**MEMORANDUM: Local Map Amendment**

**SUBJECT:** **Local Map Amendment No. 849:** "Darnestown at Travilah"  
Reclassification of 4.92 acres of land from the R-90 Zone to the RT-8  
Zone for up to 39 townhouse units, located at the north side of  
Darnestown Road, approximately 400 feet west of its intersection with  
Travilah Road, Rockville, Maryland.

**Applicant:** Winchester Homes, Inc., Applicant  
**Master Plan:** 1990 Shady Grove Study Area

Proposed Schematic Development Plan

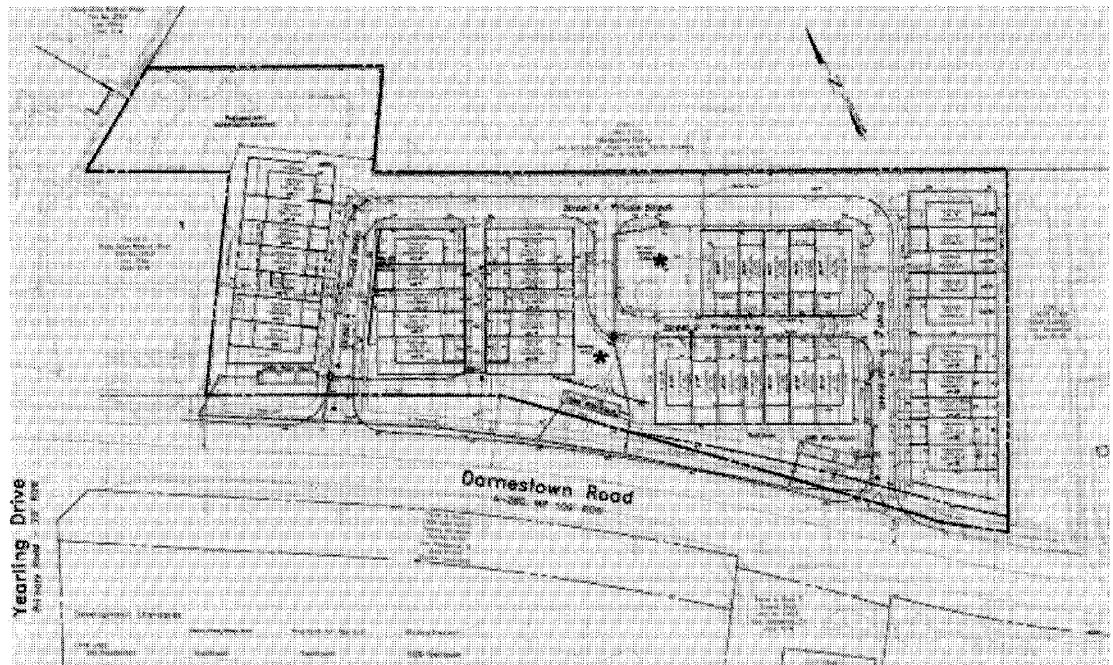
The schematic development plan for the site design/building layout does not allow space for the use of earth berms or boundary noise walls, which are the preferred noise mitigation options in such situations. The schematic development plan includes a 5-foot wall for noise mitigation, which will have only a localized effect. Specific additional noise mitigation must be shown in subsequent submittals.

Community-Based Planning staff has reviewed the revised plan submission dated May 26, 2006 and has the following comments:

- Show clearly on the Schematic Development Plan the boundaries of proposed easements (including, but not limited to, PUE, FCP, utilities, public access, etc).
- Show all grading throughout the site; provide slopes for pedestrian paths and bike path.
- Show painted crosswalks at all intersections and pedestrian crossings; label dimensions of crosswalks.
- List all Binding Elements on the Schematic Development Plan; under the List of Binding Elements, add the number of MPDUS (5) and add a statement that MPDUS will be distributed throughout the site.

- Provide handicapped access at all intersection curbs.
- Provide pedestrian refuge and bike path continuity within the island at the eastern intersection of Street and Darnestown Road; align crosswalks.

- Verify that the bike path proposed will be located entirely within the public ROW; provide gradients.
- Provide adequate turning radius for entrance/egress to private garage aprons; verify that curb cuts meet county standards (especially for Unit 7 and Unit 34; if necessary, use garageless unit).

- Provide separate parcel delineation for all SWM facilities; label parcels for SWM and show the boundary dimensions and square footage; verify that no SWM facility easement is located within any of the residential lots; verify that adequate soil depth for landscaping is provided for areas surrounding the SWM facilities.

- Adjust the curb profile for Street A (west portion) to allow the pedestrian sidewalk to be located outside of the residential lot(s).
- Verify that Forest Conservation areas will be adequately protected: show all existing significant and specimen trees; label the forest conservation parcel, show boundaries and acreage.

- Provide PUEs at 10 feet in width throughout the site (a 5-foot wide PUE is inadequate); locate PUE serving residential lots within the private streets utilizing underground connections to each unit, in order to allow for adequate landscaping with the rear yards and alley islands; relocate the PUE outside of the recreation area Tot Lot to allow for perimeter planting and safety fencing.

- Revise (or relocate) the southern-most portion of the WSSC easement located between Lots 8-12 and Lots 13-17 to allow for the construction of masonry screen walls and landscaping as visible from Darnestown Road.

- Revise the proposed grading for Lots 18-24 and Lots 35-39 to eliminate the double stair necessitated by the high finished floor levels; also, reduce the excessive number of steps required for the unit on Lot 21.
